Amendments to the Drawings:

REMARKS

Application No. 10/649,785
Art Unit 2133

Figure 5. Beta Computation Block Diagram

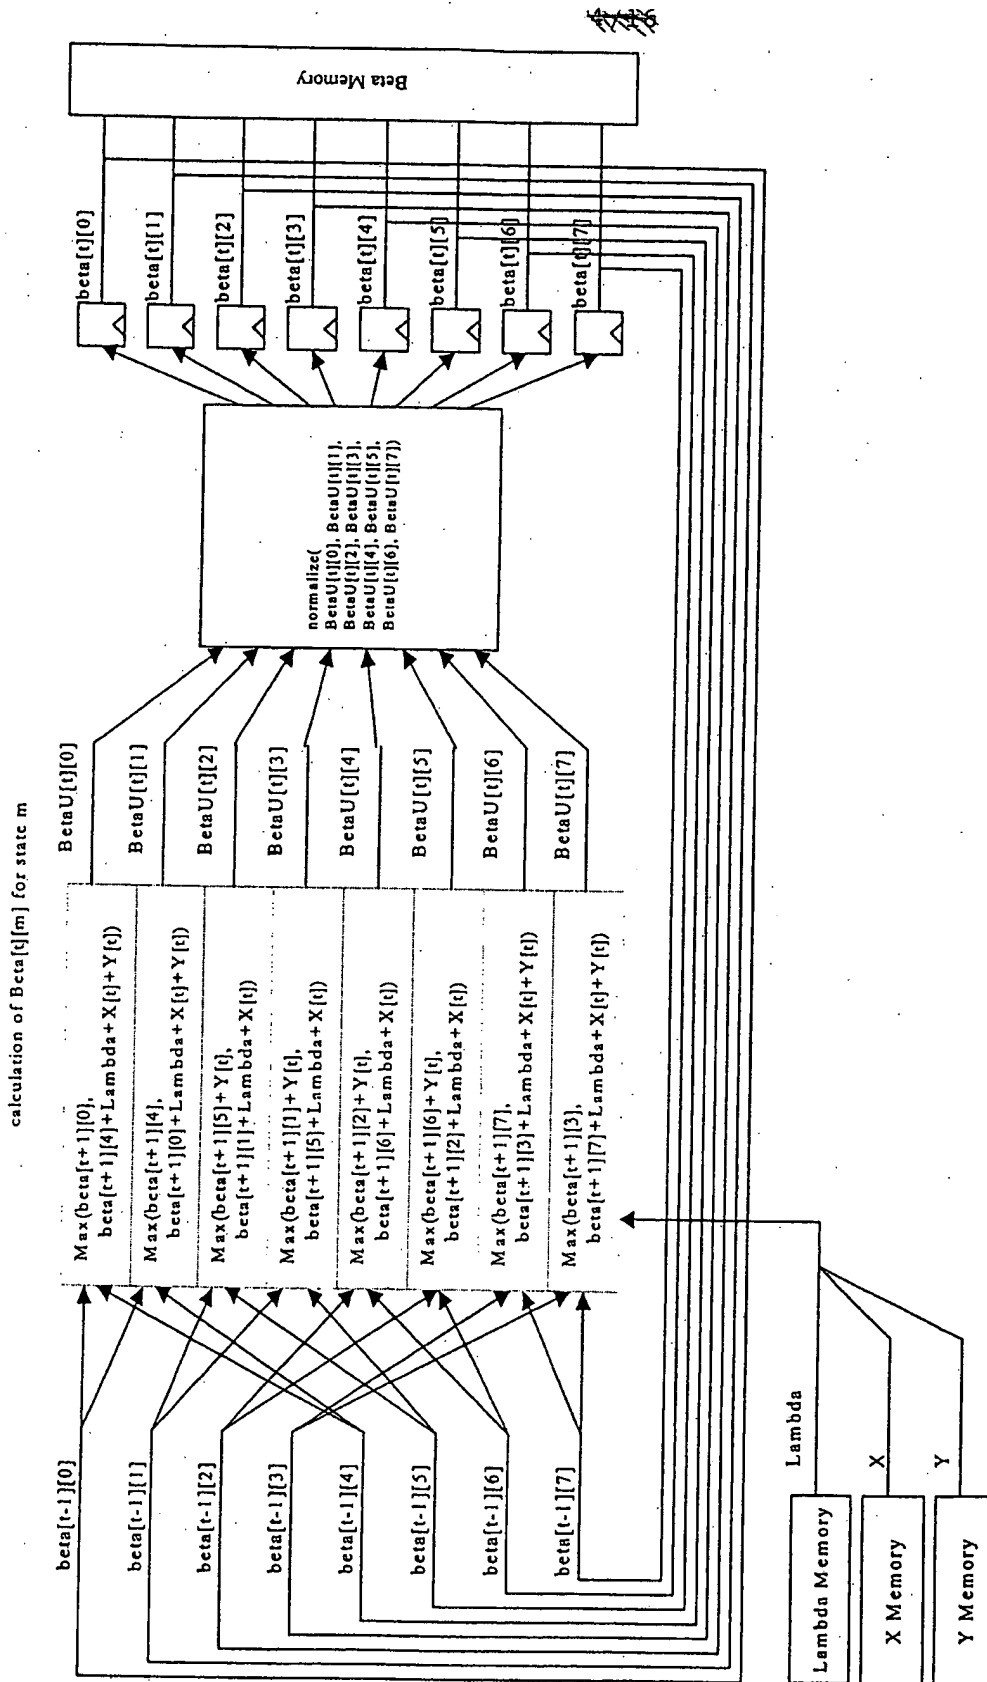
2. The drawings are objected to because Figs. 5, 6 and 10-12 should allegedly be labeled by a legend such as "Prior Art" in order to clarify Applicants' invention. Applicants have amended Figs. 1-17 by adding the legend "Prior Art" to Figs. 5, 6 and 10-12, and deleting the PCT headings (e.g. 1/16, 2/16,..., and 16/16) from each of the sixteen sheets of drawings. The replacement drawing sheets submitted herewith replace the originally filed drawings and, to the best of the knowledge of the undersigned, include no new matter.

Prior Art
